Planning and Development Services Division Vote Report

Petition: **P.Z. 07-2016 Willows at Brookings Park (Amendment to CUP #31)**: A request to amend Conditional Use Permit (CUP) #31 to amend the development conditions in an “R-1” Residence District, “R-3” Residence District, and “FPR1” Flood Plain Residence District for a 26.65 acre tract of land located southwest of the intersection of South Woods Mill Road and Brookings Park Drive. (18Q140361, 18Q140370, 18Q140352, 18Q140077).

Re: PZ 07-2016 Willows at Brooking Park (Amendment to CUP#31) REVISED

Figure 1. Proposed parking setback changes proposed

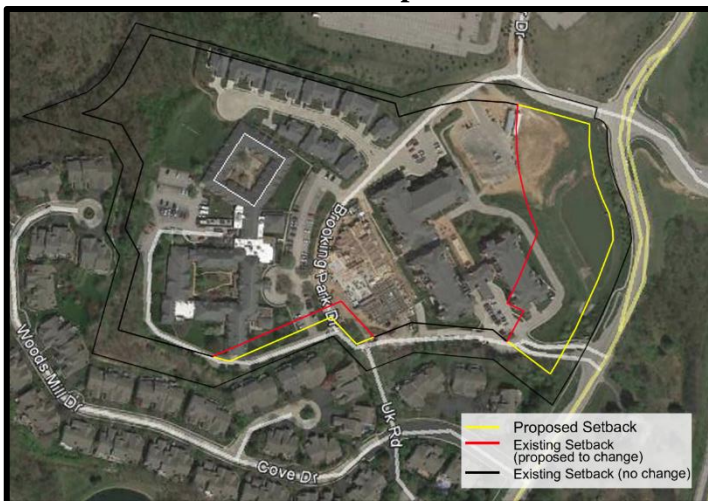
There are two changes the parking setbacks requested, and both can be seen in figure 1 above. The first is to change the setback along the eastern boundary, along Woods Mill Road. This change would allow for future parking further away from residential. Additionally, the setback change would allow Building E to have a below level or first level parking garage. Staff has no concerns regarding this change.

The second request is to change the setback along the southern boundary line. This change would allow for additional parking along the southern drive aisles. Two new parking areas are shown on the plan adjacent to a single family residential subdivision. As mentioned previously, the attached agreement between the applicant and the adjacent residents details various actions that the applicant has agreed to in order to mitigate any concerns. Staff has no concerns regarding this change.

1 Terrace Landscape Plantings @ Proposed Parking Lot

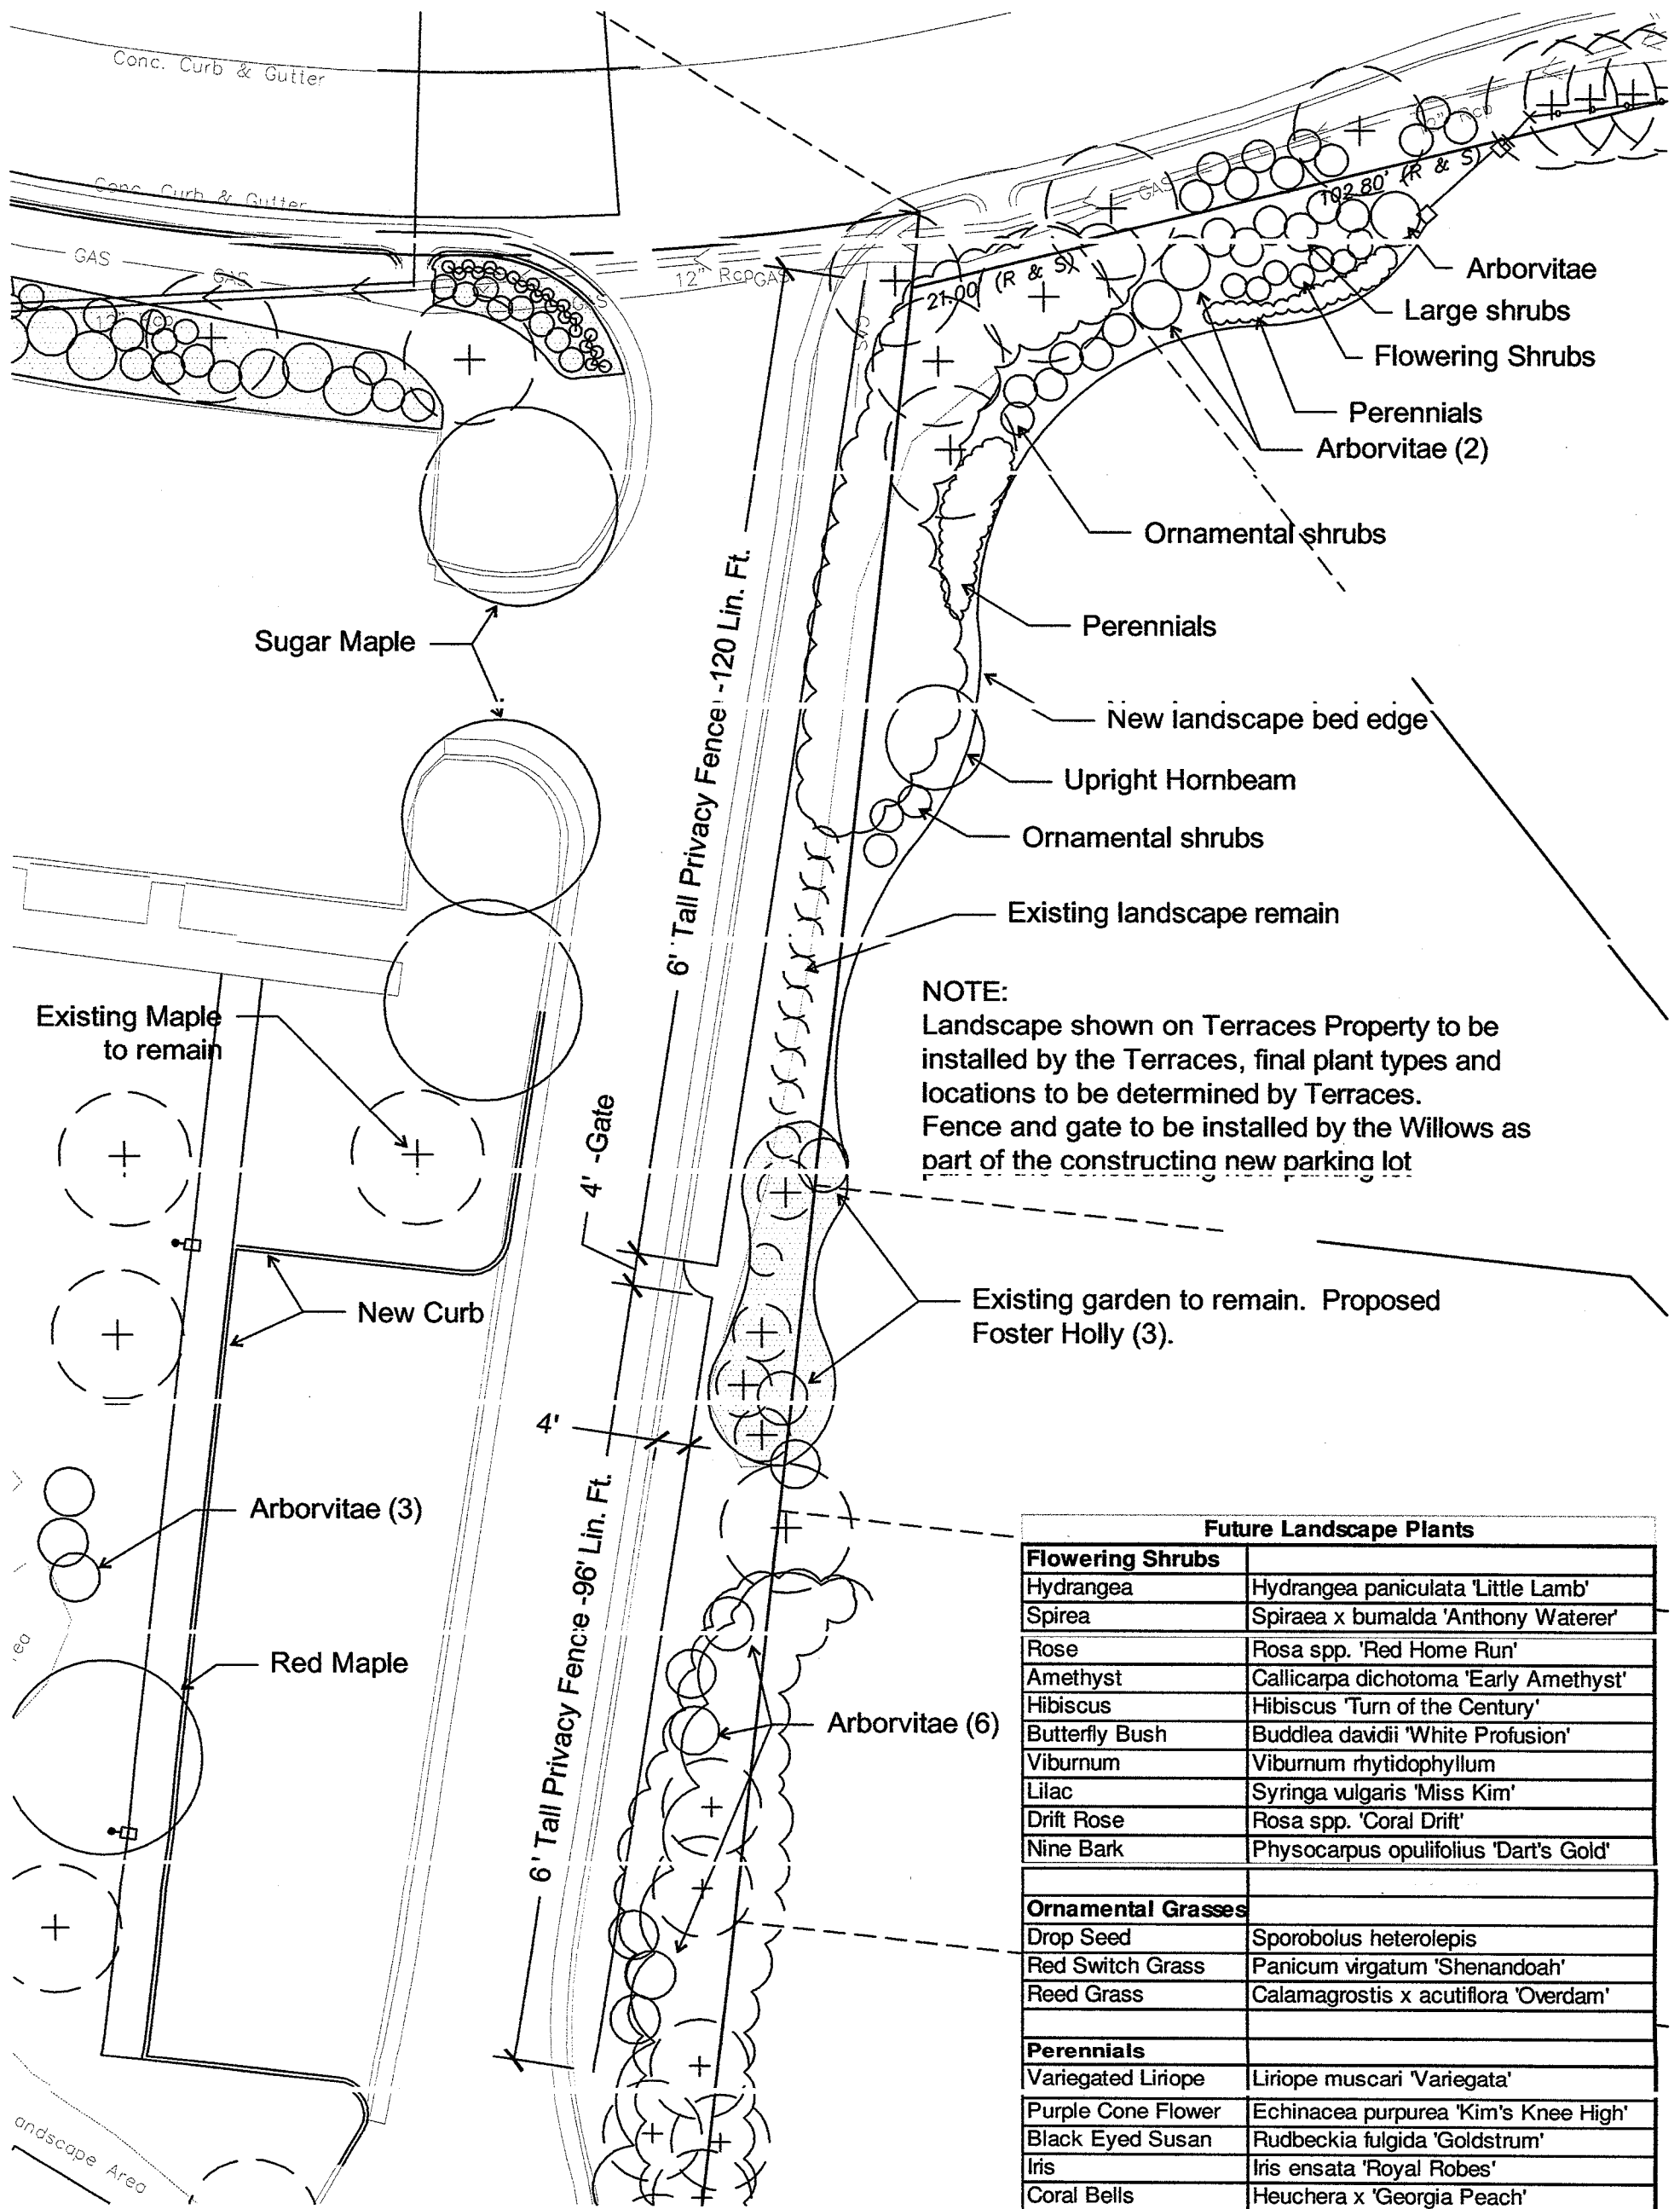
1. Terraces requested we keep the red maple tree which would mean a loss of 33 spaces. Clarified that additional landscaping will conform to City of Chesterfield Standards.
2. Terraces requested a 6' high vinyl fence which would run from the east corner of Mr. Grewe's property to approx. the 3 lot to the west. Additional landscaping will be put in on the Terraces side of new fence.
3. Ed Dermody to meet with the Terraces to design needed landscaping. See attached drawing; "Terrace Landscape Plantings @ Proposes Parking Lot dated Dec. 12, 2016". Budget for this work was set at \$5,000.
4. Terraces requested bollard light standards in this parking lot. Will look at how many and what kind.
5. Terraces requested proper SWPP drainage of parking areas under constr. Will ask BSI to put in "log" retention at basin to west of constr.

SD1

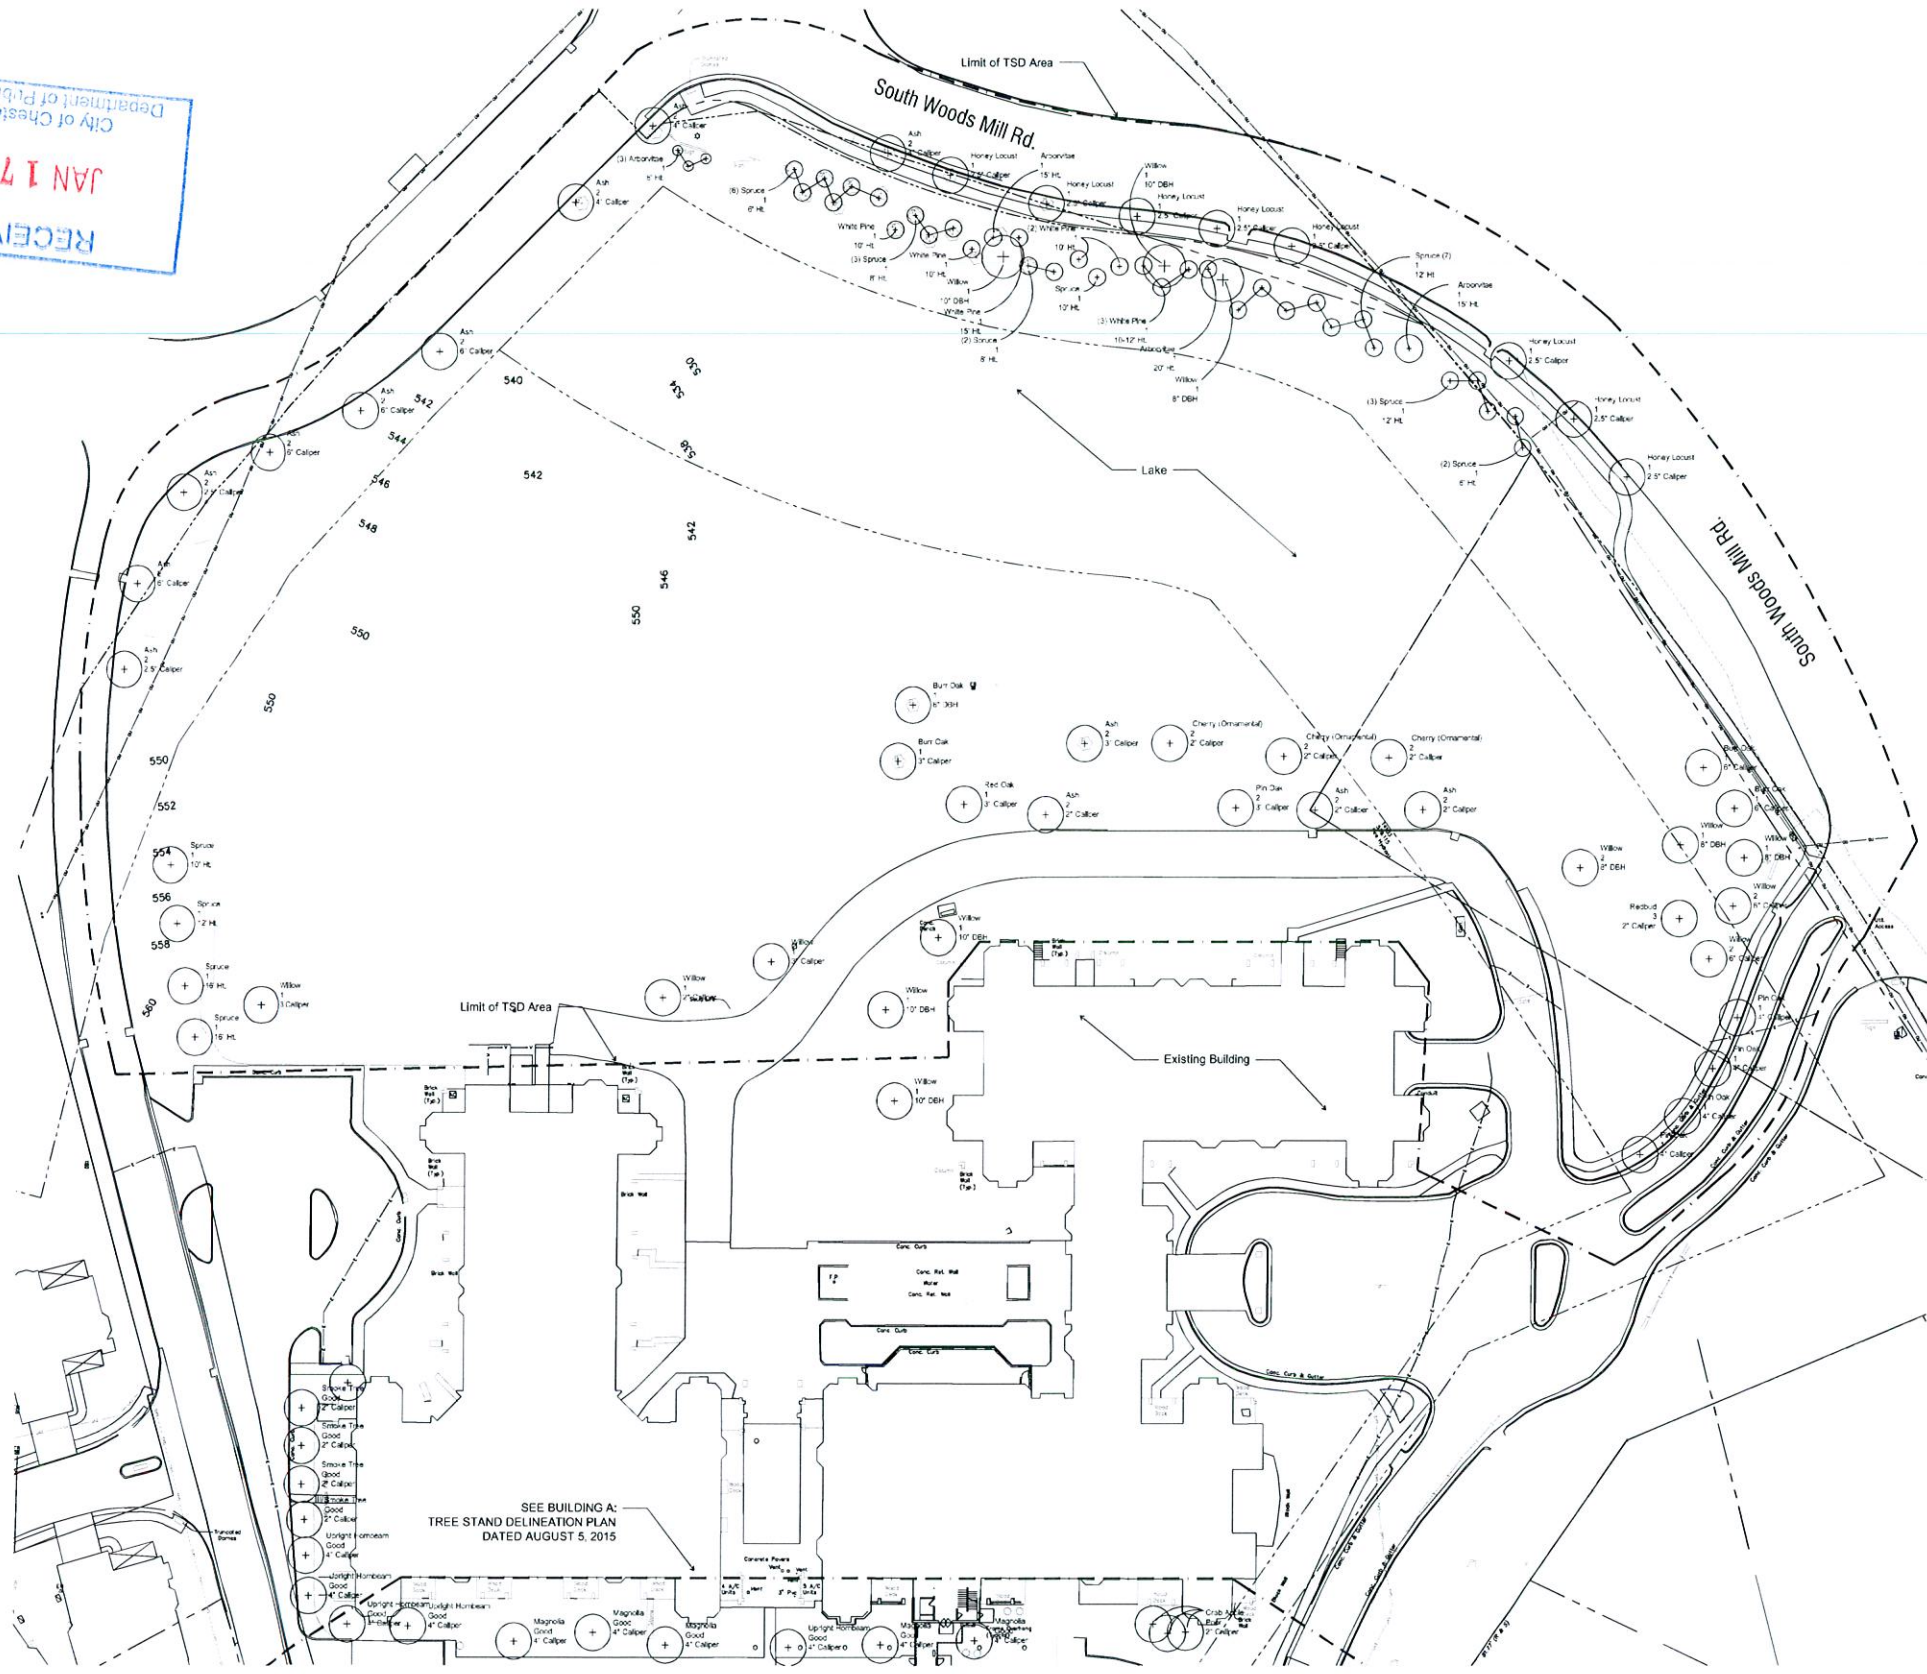
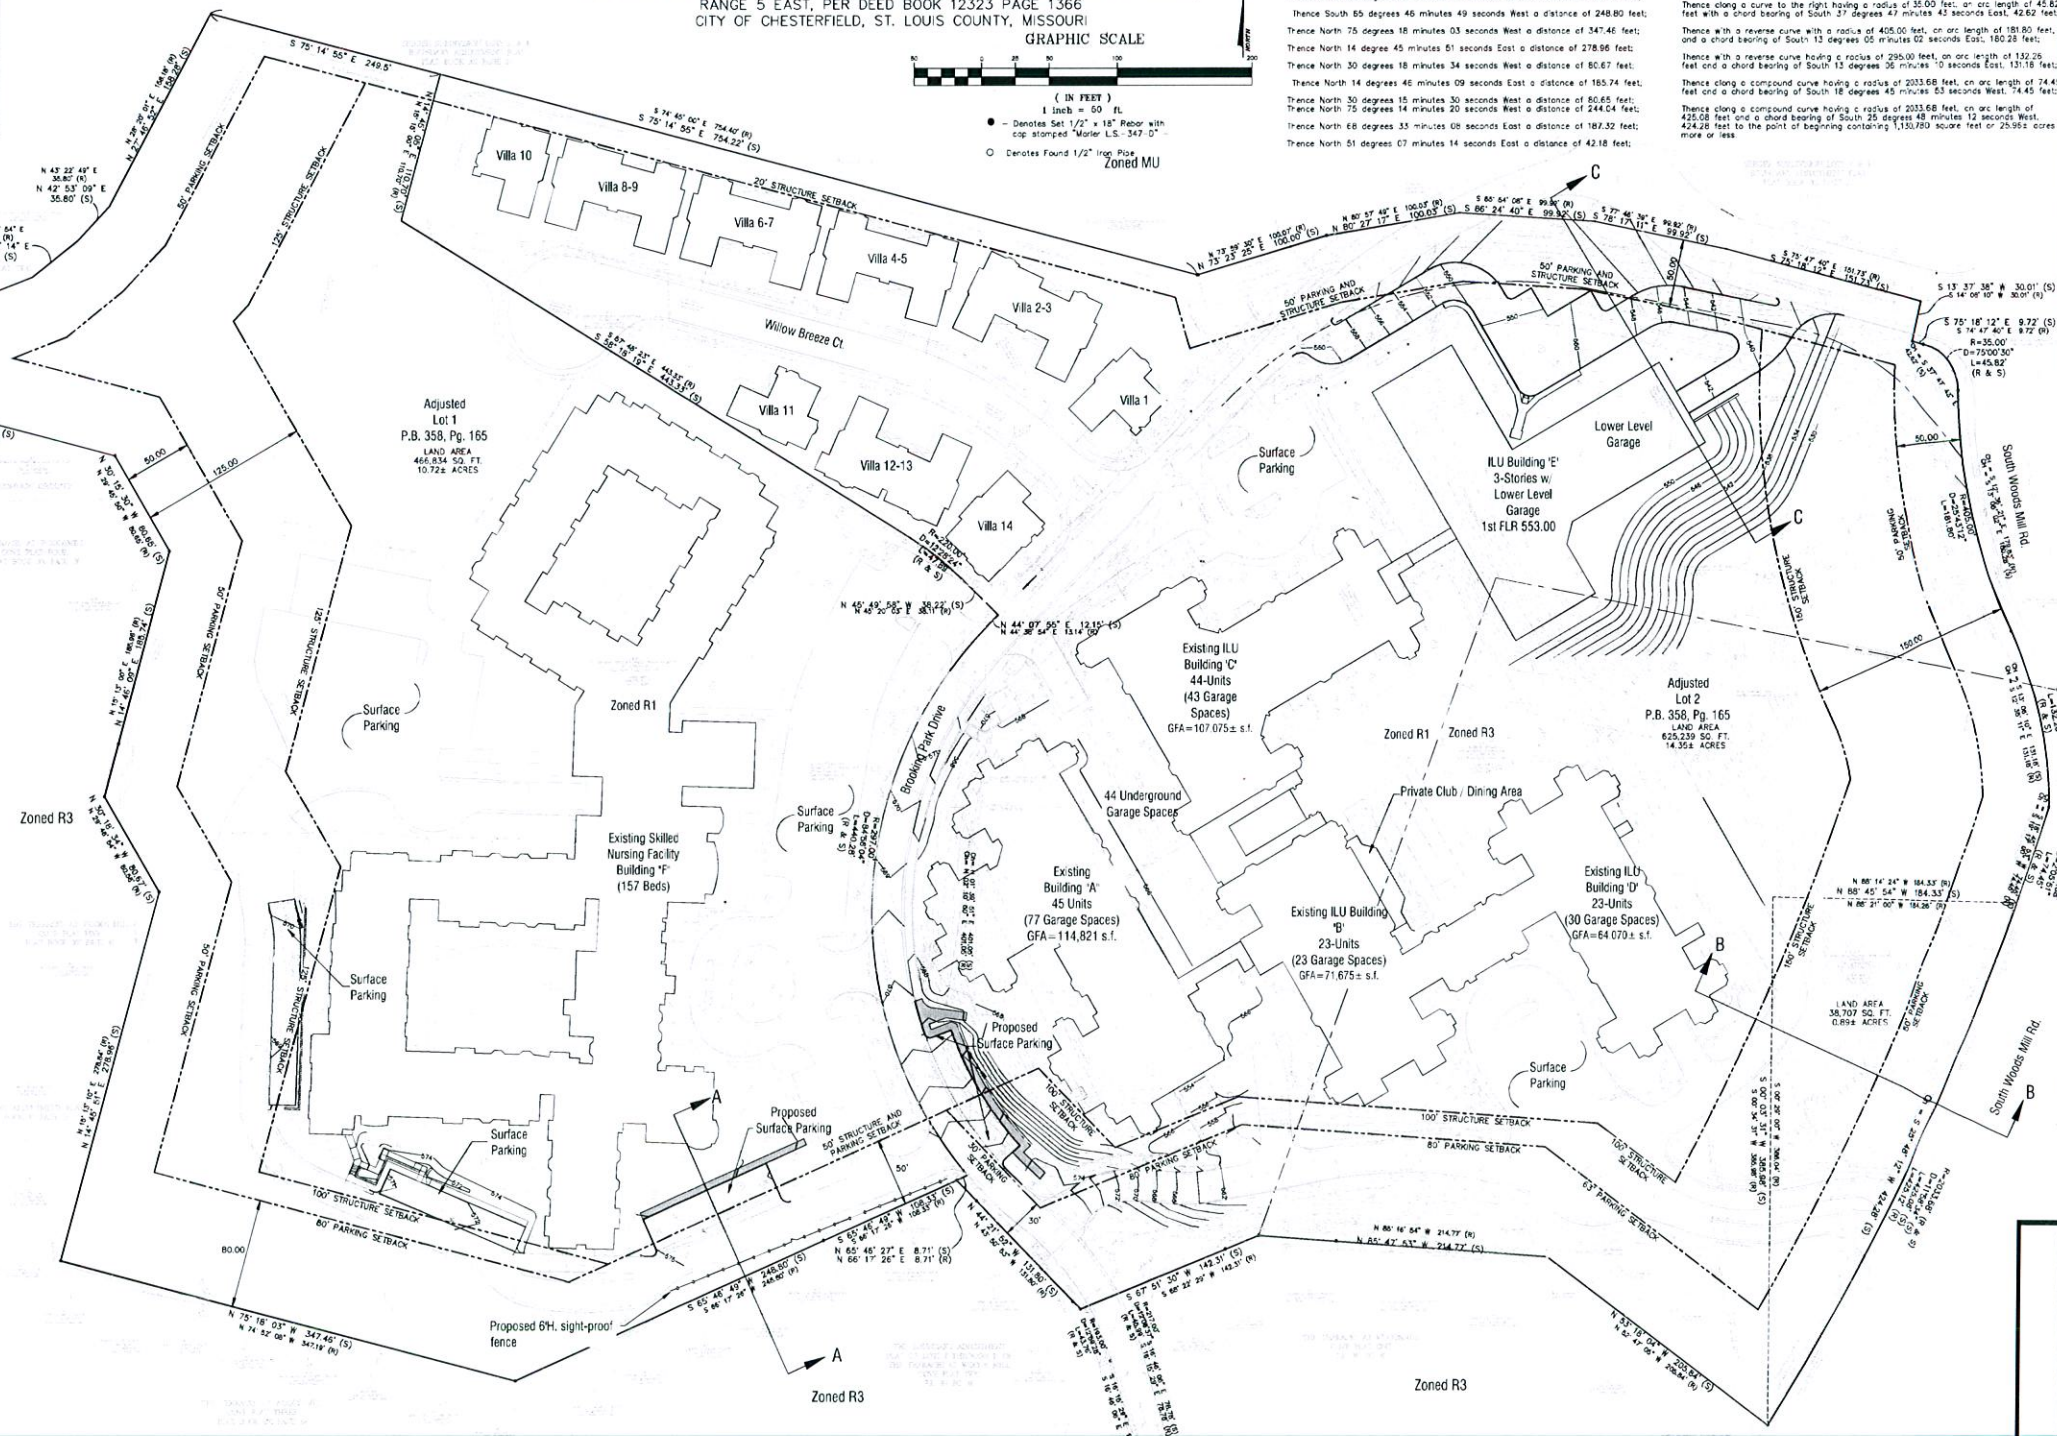
2. *Confirm the following parking space count is correct:*
 - *Required parking: 143*
 - *Provided parking: 433 (excluding building E)*

Comment 1: Evaluate the potential to amend the parking setback request in order to save any trees. The Unified Development Code (UDC) allows some variation of parking space dimensions for compact cars. The standards for parking stalls and drive aisles policy has been attached.

Comment 2: Confirm the parking space count is correct.

In response to this issue, the applicant has since changed the Preliminary Plan to reduce the number of parking spaces and keep the tree discussed.

The applicant has indicated that a count of existing parking was conducted to find that actual provided parking is 407. The preliminary plan has been updated to specify the number of spaces in each area.

Response 1: The Willows at Brooking Park has worked with the residents of The Terraces at Woods Mill and reached an agreement regarding the proposed parking and landscaping. The proposed number of stalls at the southeast corner of Brooking Park was reduced by three (3) spaces from fourteen to eleven. By eliminating three parking spaces, the red maple tree is able to be saved.

Response 2: In response to the city comment regarding the parking, the Willows prepared a parking analysis of their existing campus which included the number of employees working within each building as well as the number of caregivers that are independently contracted by the residents. The parking for the caregivers has been factored in to the calculations. The resulting parking calculations are as follows:
